Lindon City Planning Commission Staff Report

July 27, 2021

Item: 5 and 6 Site Plan and Minor Subdivision Approval Rhino Realty LLC – 570 North State Street

Item: 7 Site Plan Approval – Lindon Fizz – 195 North State Street

LANDSCAPE PLAN

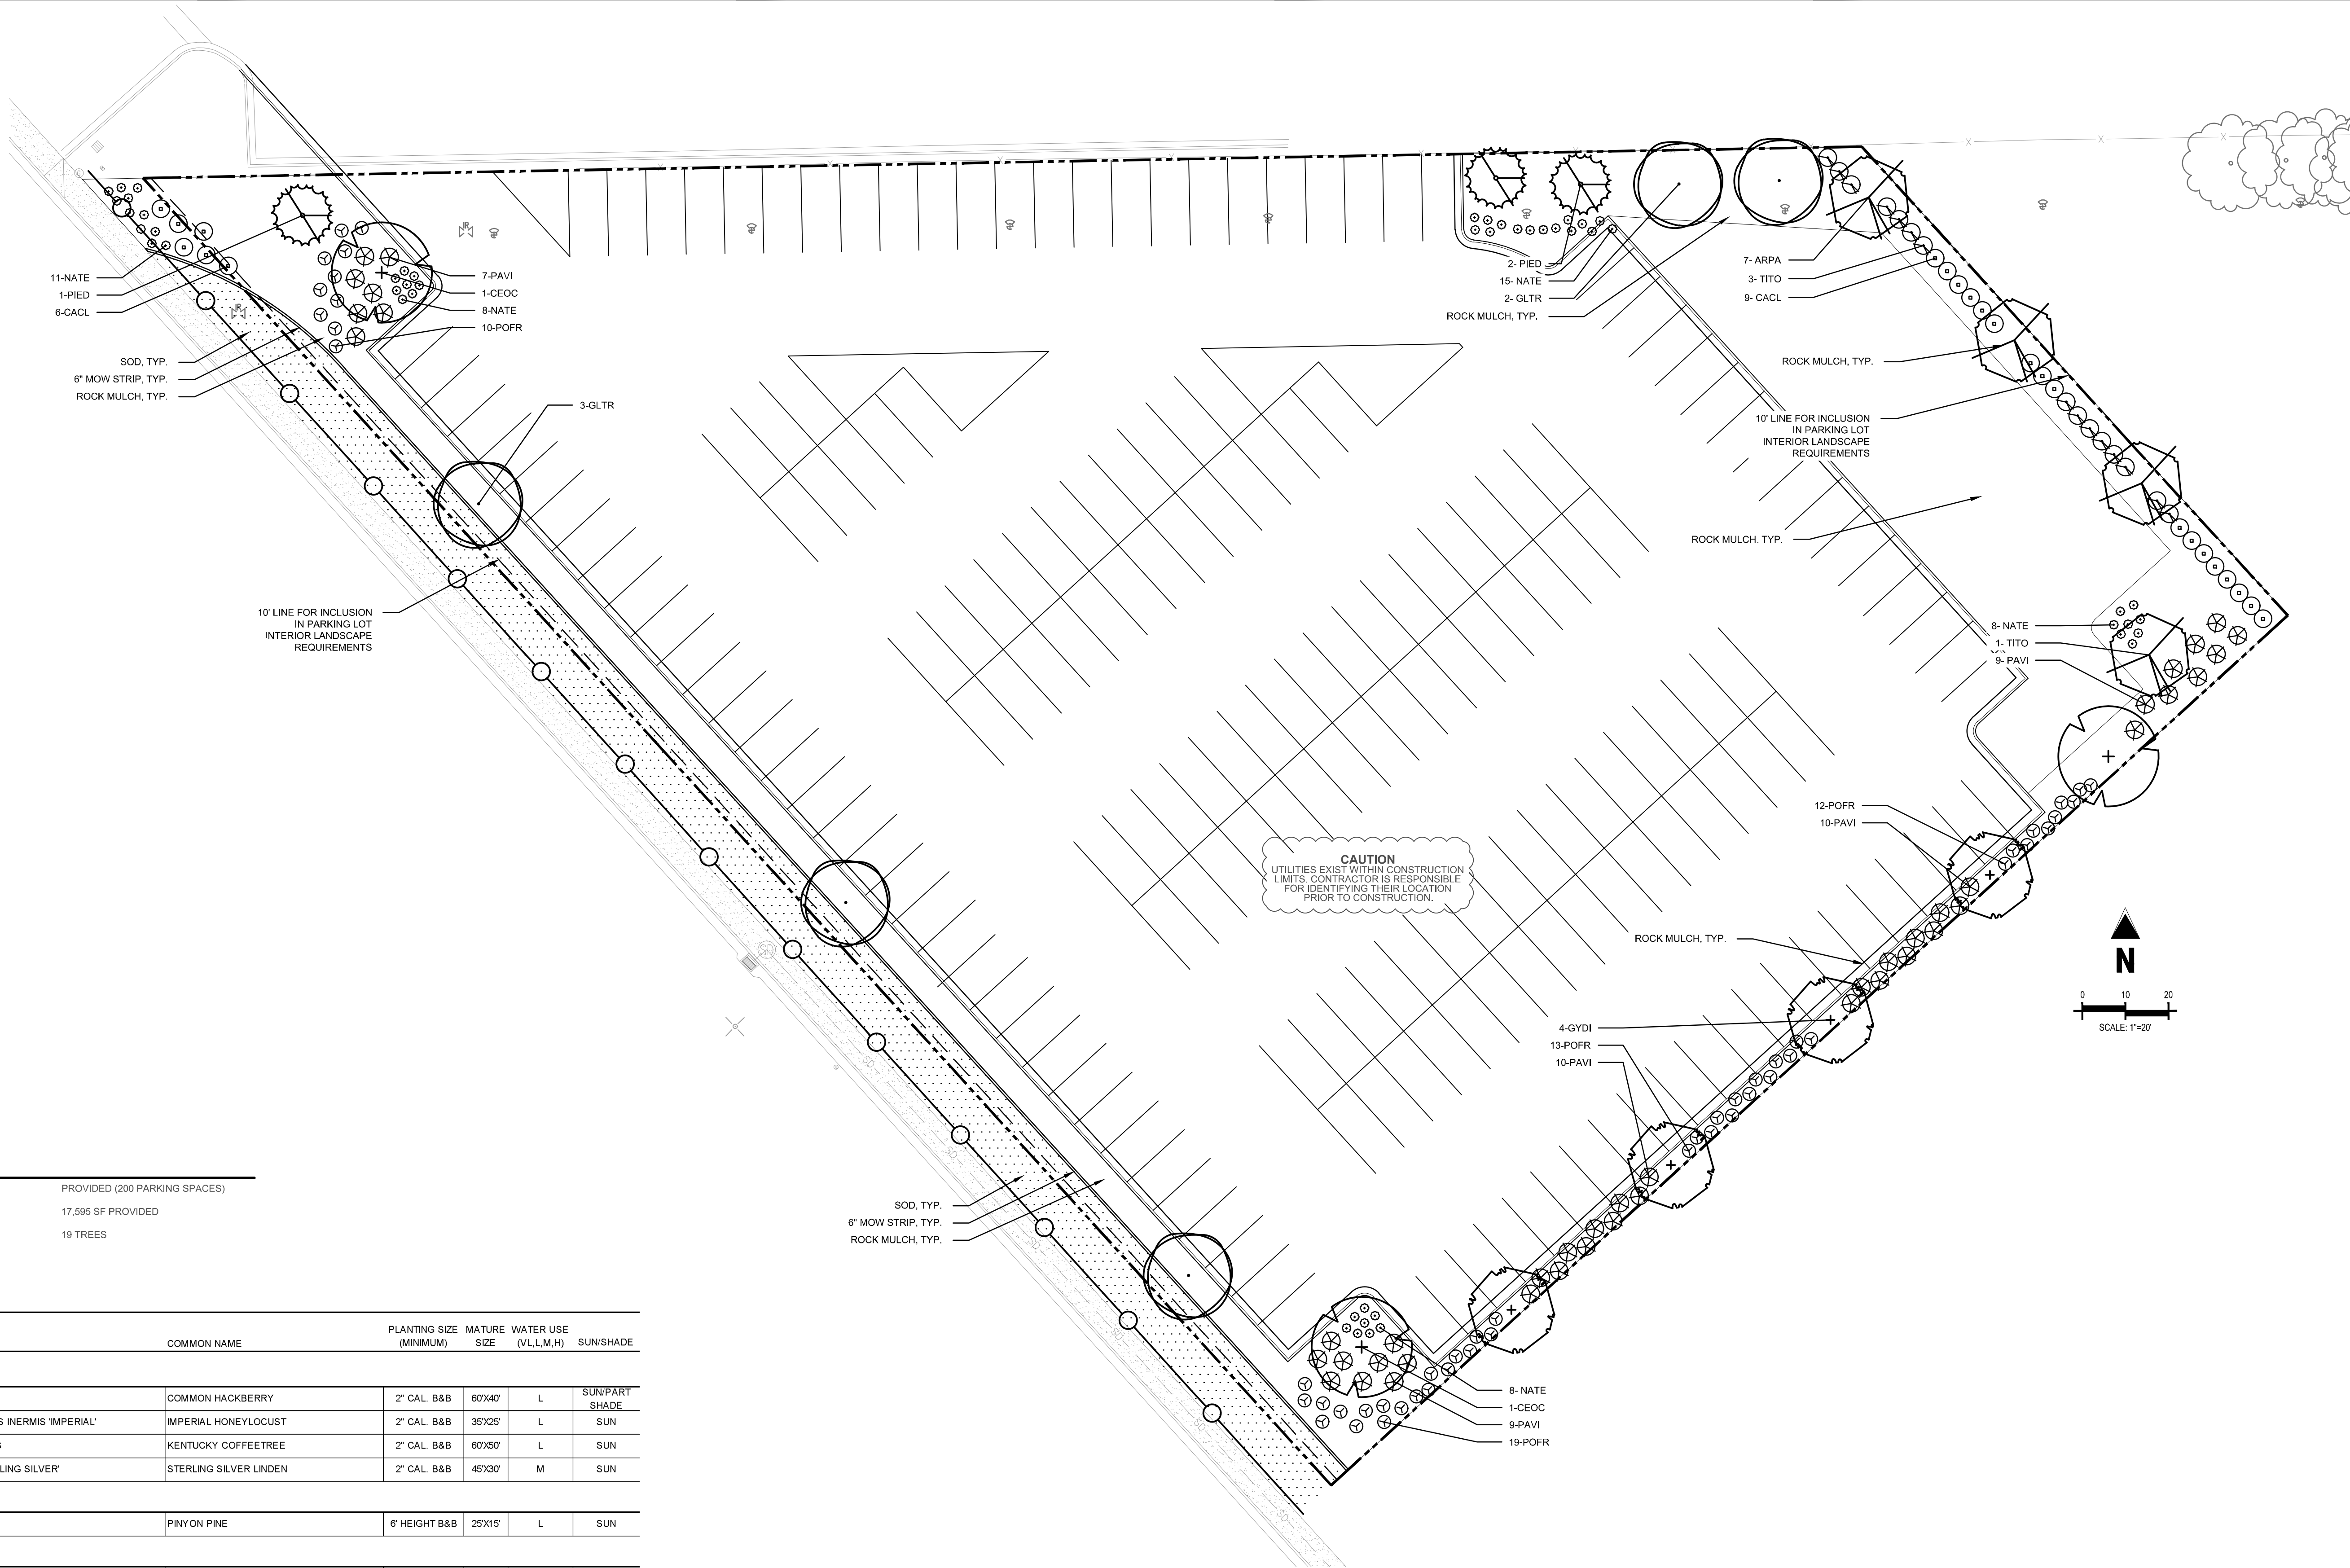
1. An updated landscaping plan will show that 40 square feet per parking stall of interior parking lot landscaping will be provided and that 75% of the interior parking lot landscaping consists of living vegetation according to section 17.18.085 of the Lindon City Code;
2. The applicant will continue to work with the City Engineer to make all final corrections to the engineering documents;
3. The plans will meet development specifications as found in the Lindon City Development Manual;
4. The applicant will comply with all bonding requirements, if applicable; and
5. All items of the staff report.

1. The landscaping plan does not provide a sufficient number of trees in the landscaped buffer in addition to other landscaping requirements that are not being met as described in the above table. The Planning Commission may approve some parts of the landscaping plan that is presented according to section 17.48.030 of the Lindon City Code which states the following: "Landscaping requirements concerning berming, trees, and landscape materials can be changed and/or altered (with regard to location and design) upon approval of the planning commission at the site plan review stage of an application. No net loss of landscaping should occur with any approved alterations. Other landscaping layouts consistent with the Lindon commercial design standards may also be considered by the planning commission."

MATERIAL BOARD

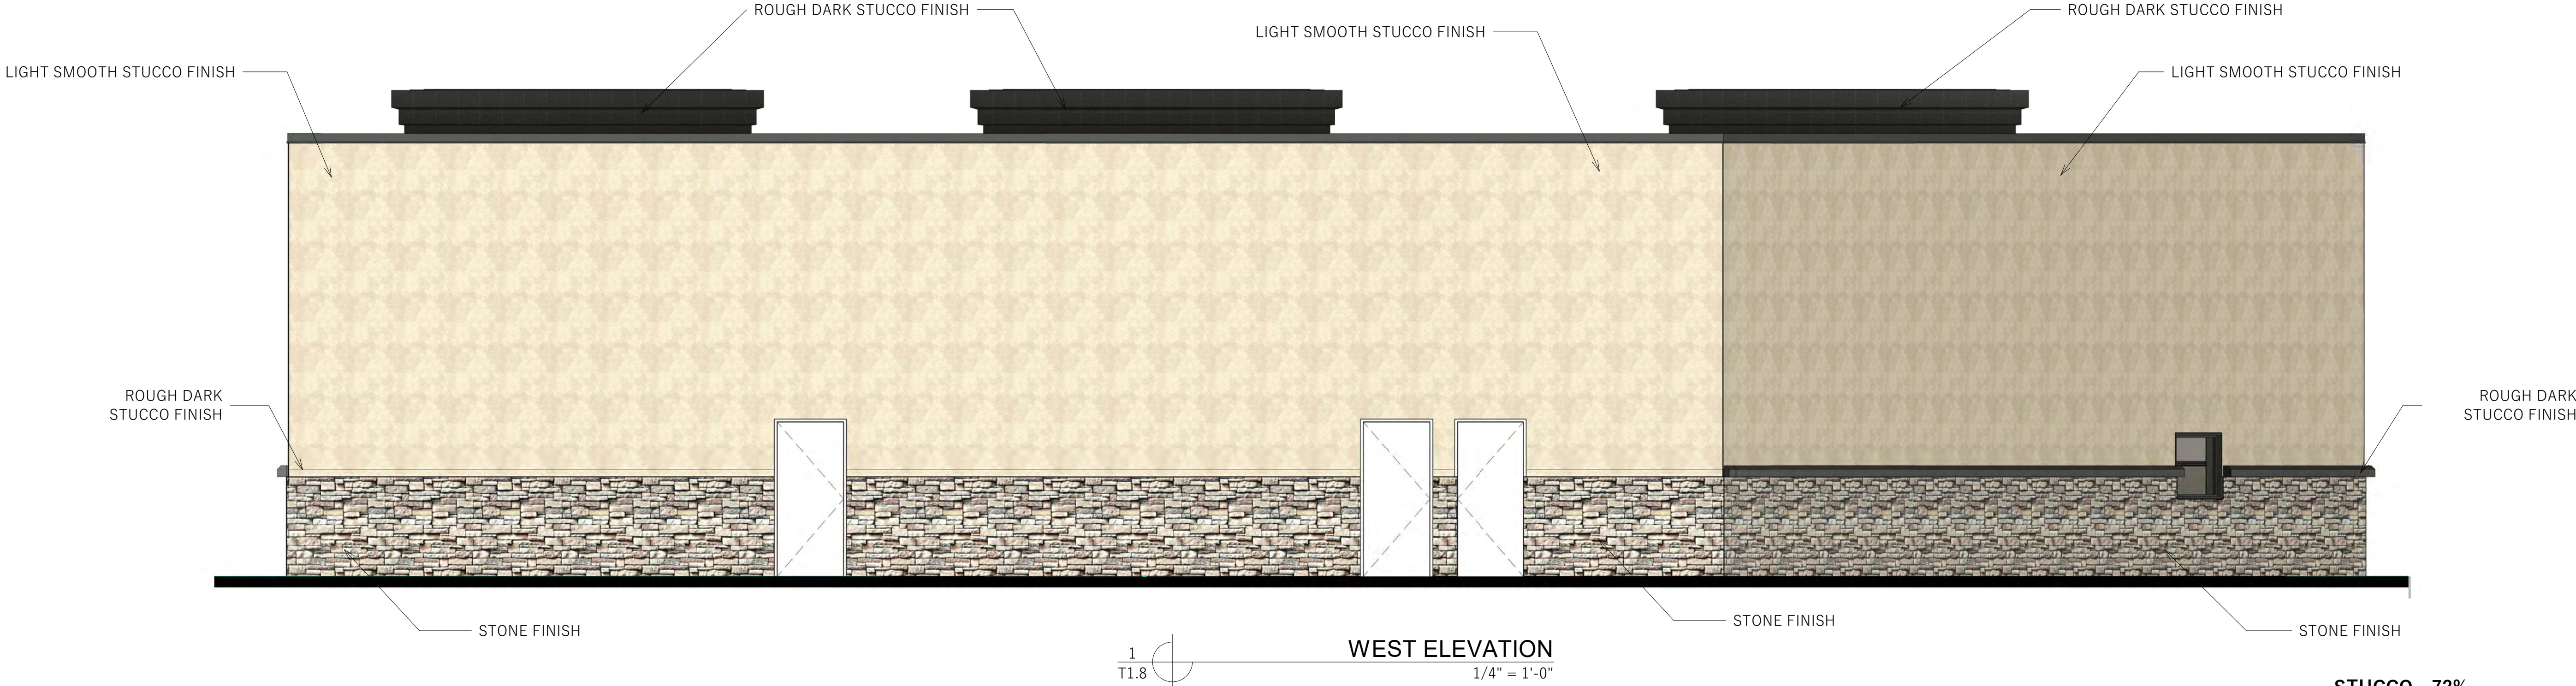
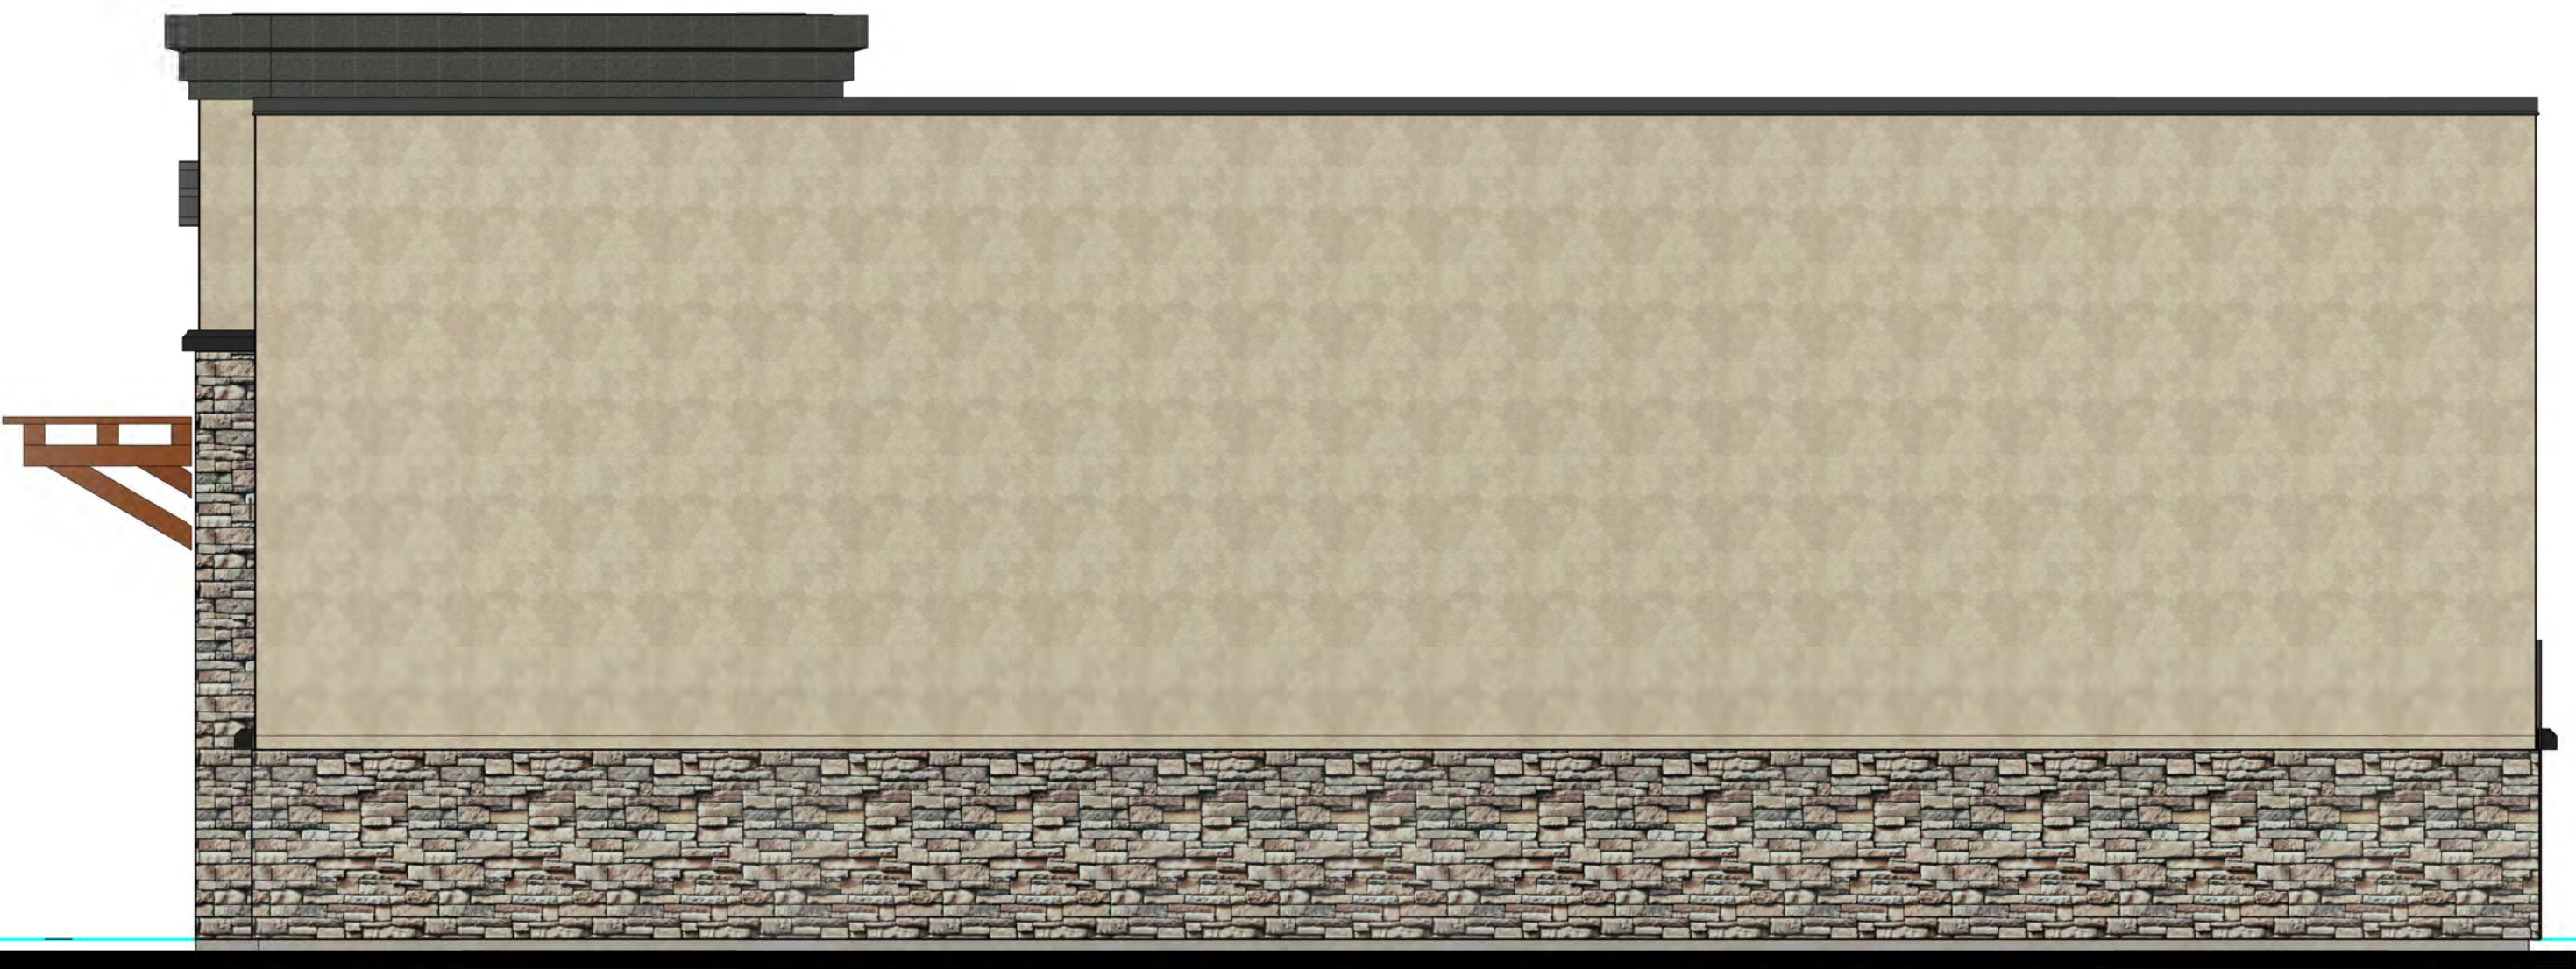
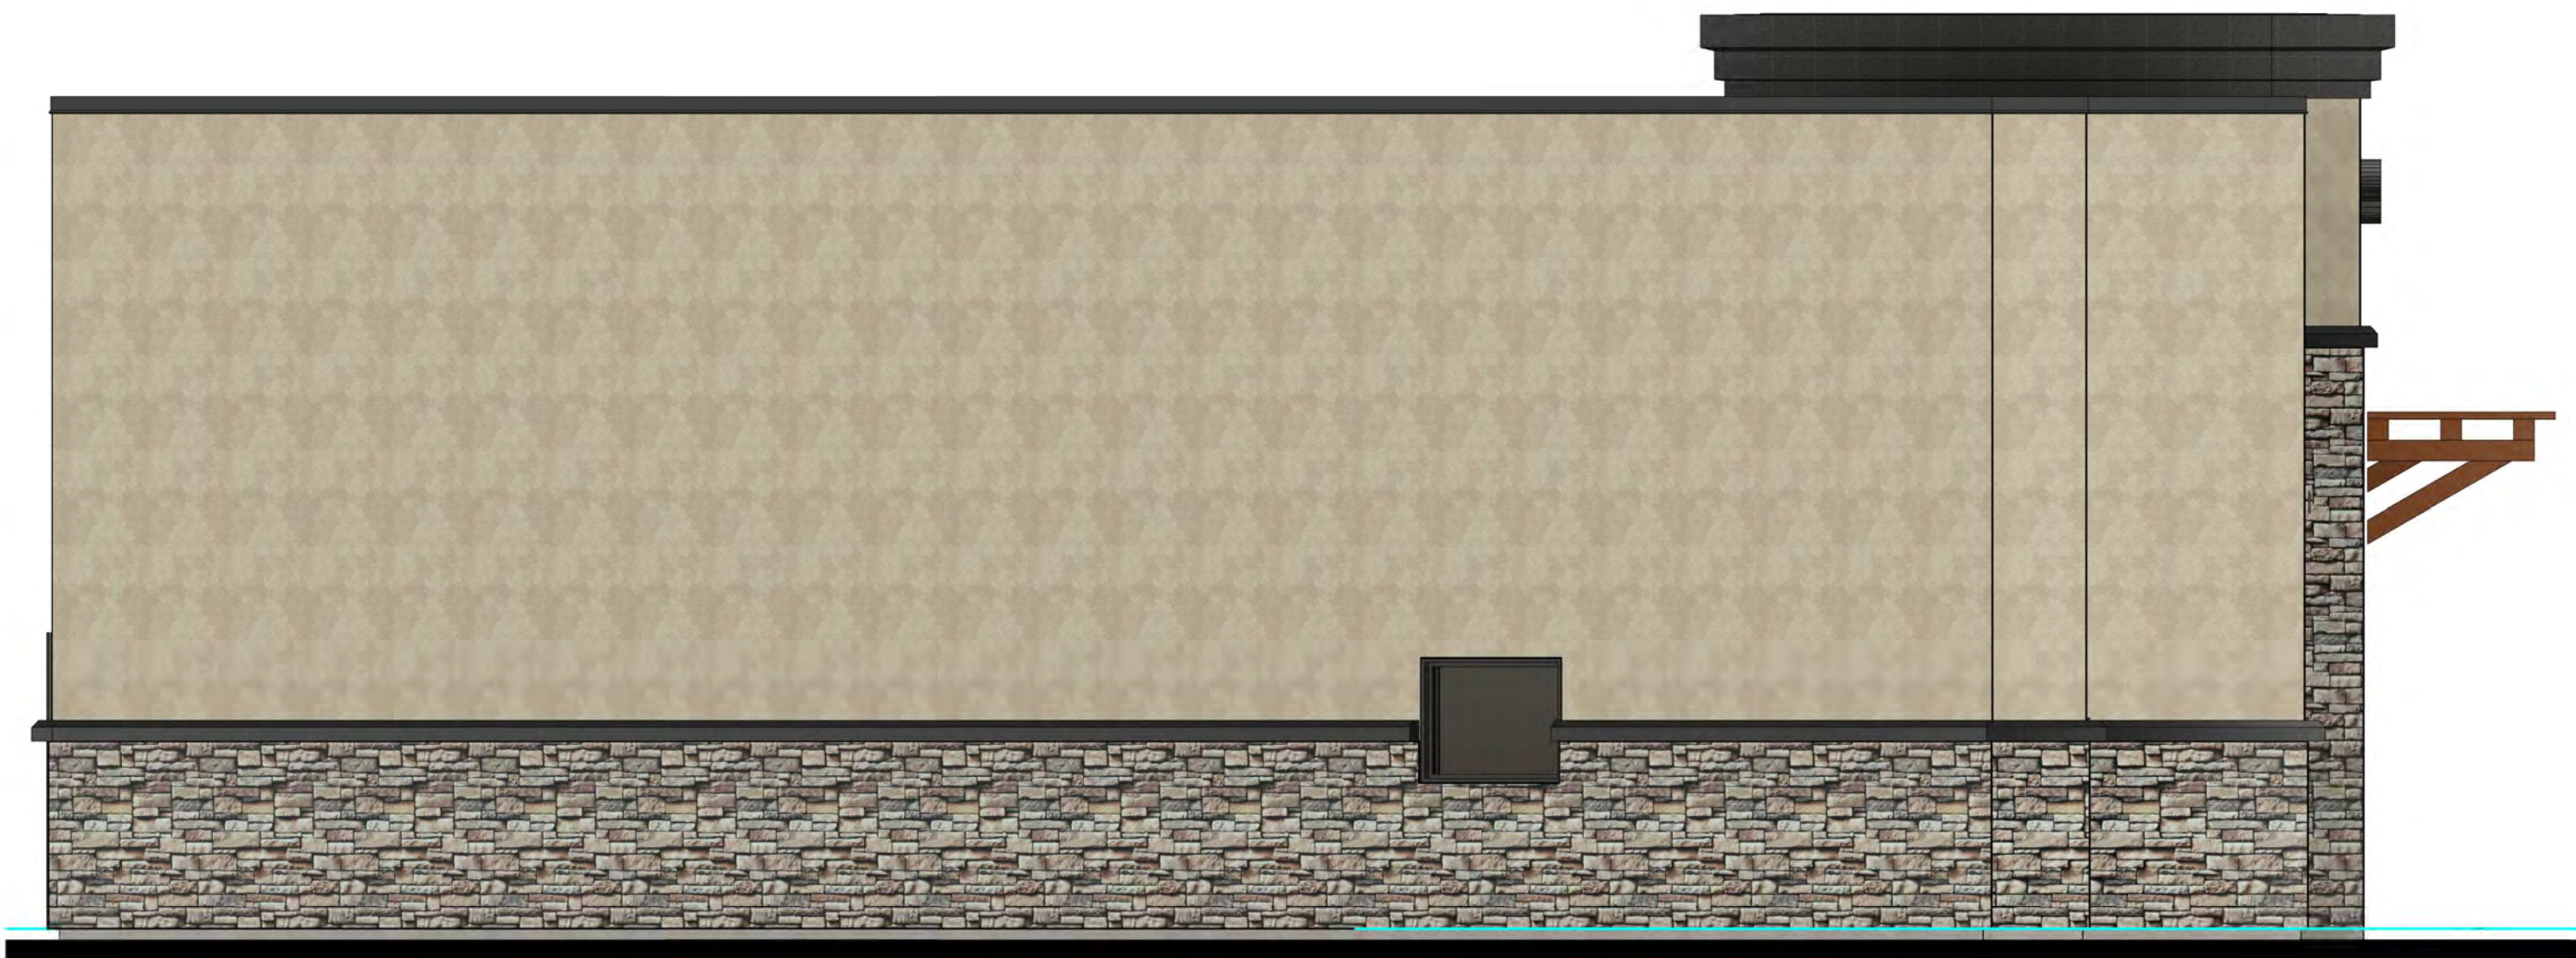
Roofing	Sloped roofs should be the primary roof form and should use a material that is compatible in material and color with the exterior material of the building. Flat roofs can be used, but should always be used with a parapet and/or decorative cornice.	The applicant is requesting a flat roof design. The building has both parapet and cornice designs.
Exterior Walls and Surfacing (building Materials)	Brick, stone, or colored decorative block should be utilized as the primary building material (85% or greater of the building), especially on street-facing facades. All of the above, as well as stucco, wood, architectural metals, colored decorative concrete and cement board siding may be used as secondary (less than 40%) building materials, and on less visible facades.	The building materials consist of a combination stucco and stone with a wood canopy over the doors. The front façade of the building consists of 61% rock and fenestration and 39% stucco.

SITE CONCEPT PLAN	
WORTH PARTNERS	
CONCEPT PLAN	
LINDON CITY, UTAH COUNTY, UTAH

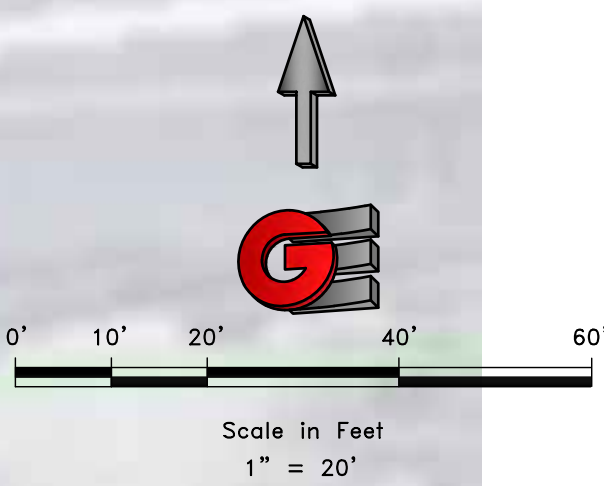
1. Concept reviews are to provide general feedback only and no decision will be made or voted on at the meeting.
2. The applicant is proposing a development consisting of three drive-thru buildings
3. The applicant is requesting feedback about decreasing the required landscaping along 200 N. from 20' to 8'.
